# Lower Thames Crossing

## 9.224 Applicant's response to Procedural Decision 45 The Wilderness

Planning Inspectorate Scheme Ref: TR010032  
Examination Document Ref: TR010032/EXAM/9.224

**Plate 1.1 Existing land use in proximity to The Wilderness**

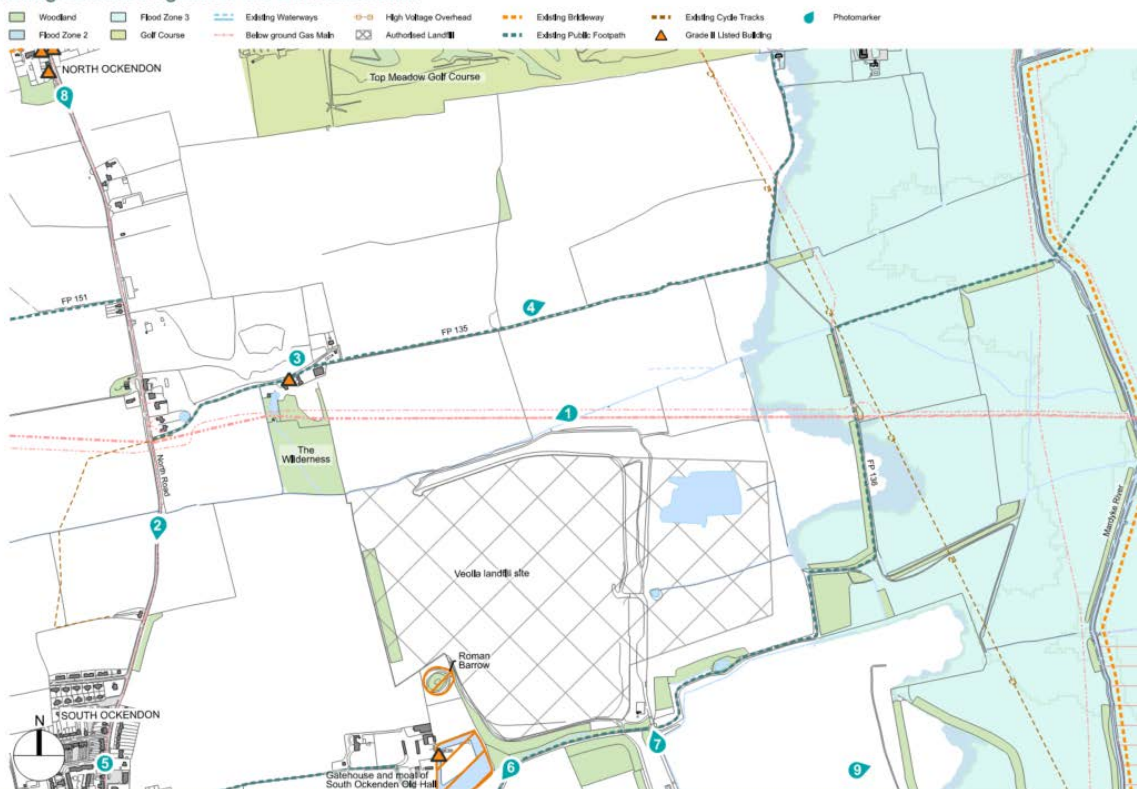
**F. Are there any additional siting or design measures that the Applicant can take to eliminate or further reduce the effects of the Proposed Development on 'The Wilderness' land shown hatched blue in Annex A, beyond or in more detailed and clearly justified terms than those identified in the response to ExQ3 11.1.8 [REP8- 115]? If so, what are those measures? If it is concluded that no such measures can reasonably feasibly be taken, what are the reasons for this conclusion and is any additional reasoning beyond that provided in response to ExQ3 11.1.8 needed in order to respond to NPSNN paragraph 5.3.2?**

1.2.3 As outlined in Issue Specific Hearings 1, 3 and 9, the alignment of the Project in the Ockendon area is dictated by a number of constraints including in particular The Wilderness and the existing working landfill site, operated by Veolia. These constraints, together with the Preliminary Design are shown in Plates 1.1 and 1.2 below, which are extracts from the Project Design Report: Part D: General Design North of the River – North of the A13 Junction to the M25 [APP-510] pages 22 and 23. As can be seen, the southern tip of The Wilderness is coincident with the northern boundary of the working landfill site.
